Preliminary Drainage Report
for
Windingwalk Filings 1 & 2 PUD
and
Final Drainage Report
for
Windingwalk Filing 1
at
Meridian Ranch

March 2018

PCD Project No. PUDSP-18-002
SF-18-002

Stormwater Detention and Infiltration Design Data Sheet

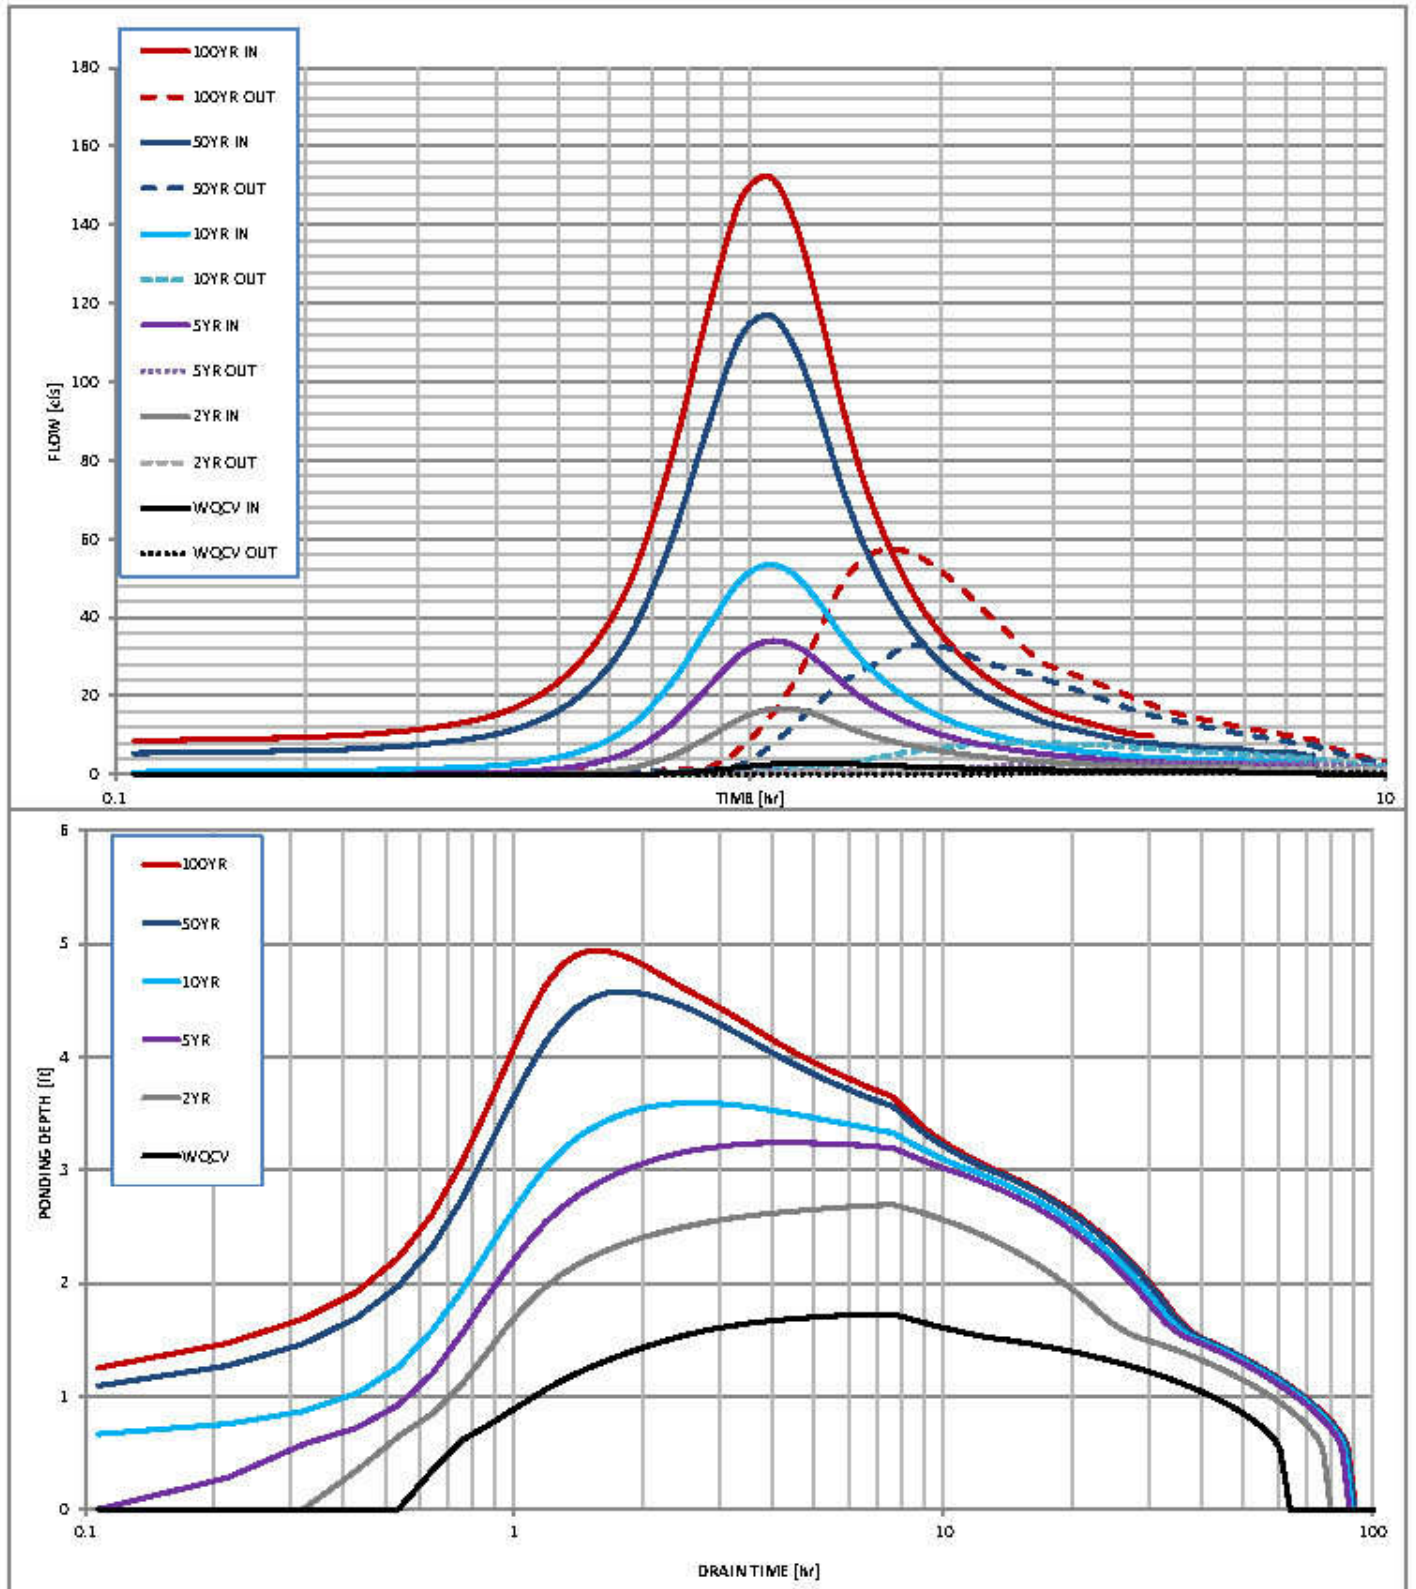
Remove the SDI Worksheet from the Drainage Report and upload as an additional document in eDARP.

FIGURE 4

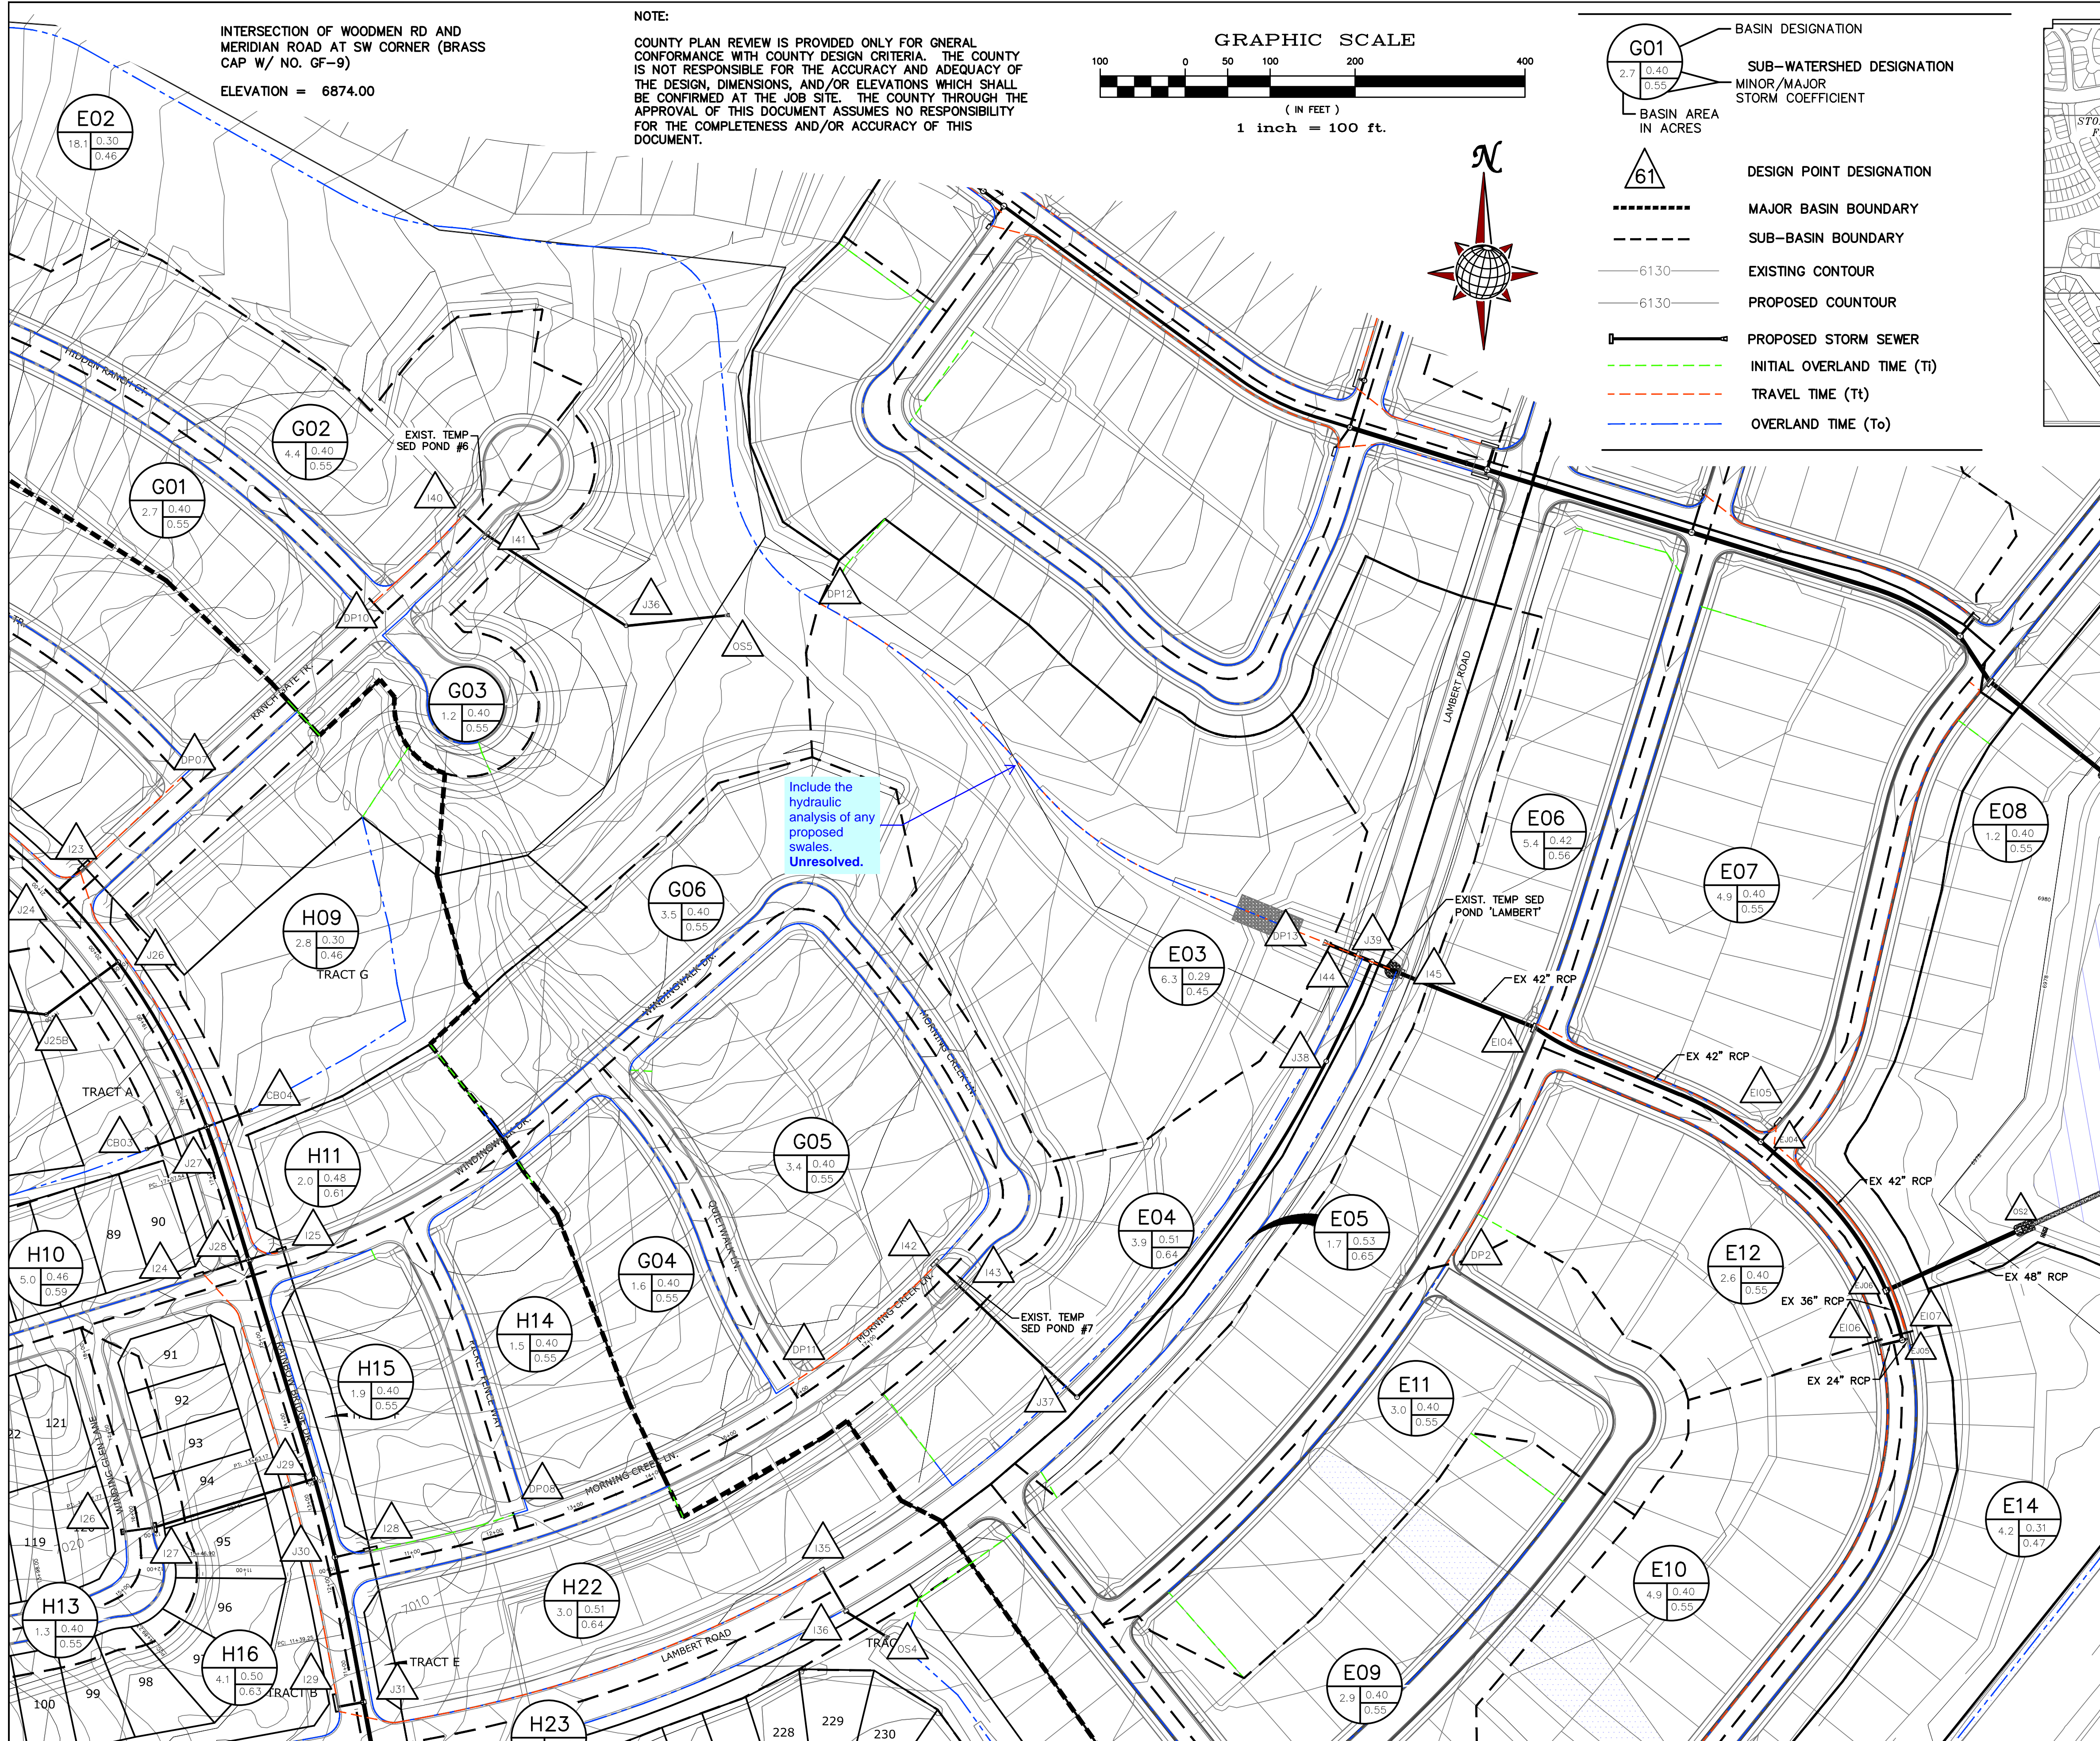
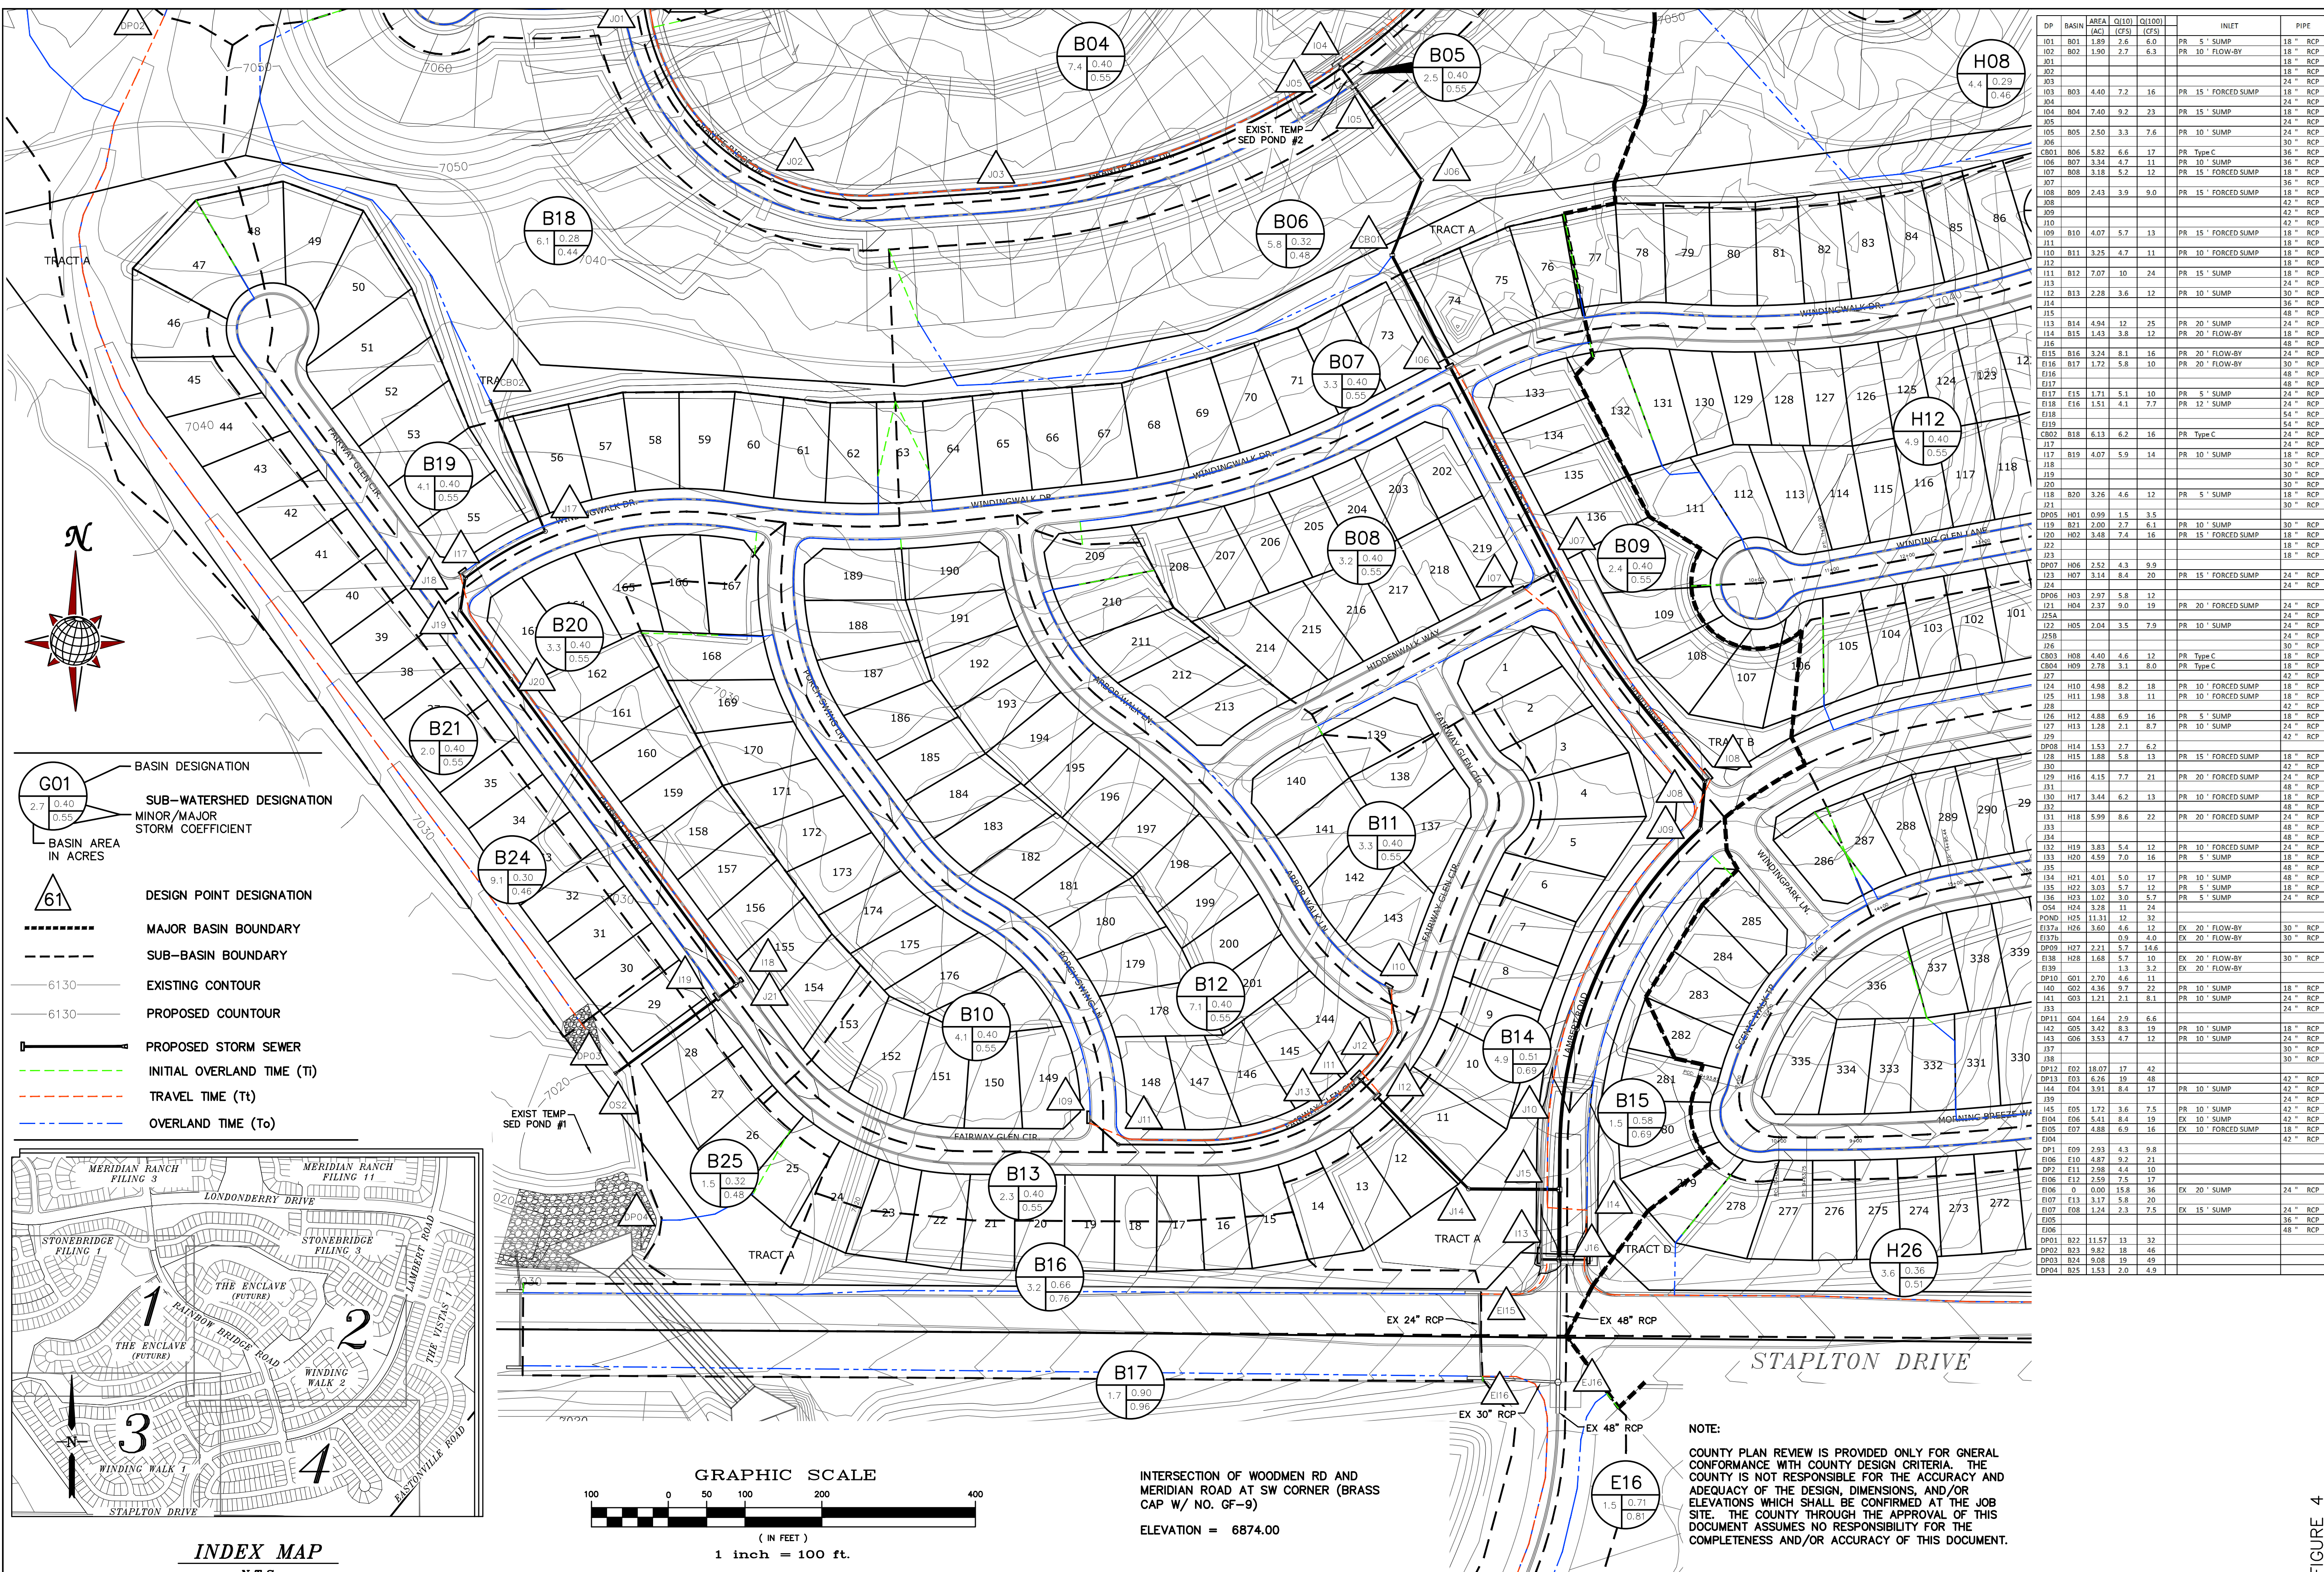
Include the hydraulic analysis of any proposed swales. Unresolved.
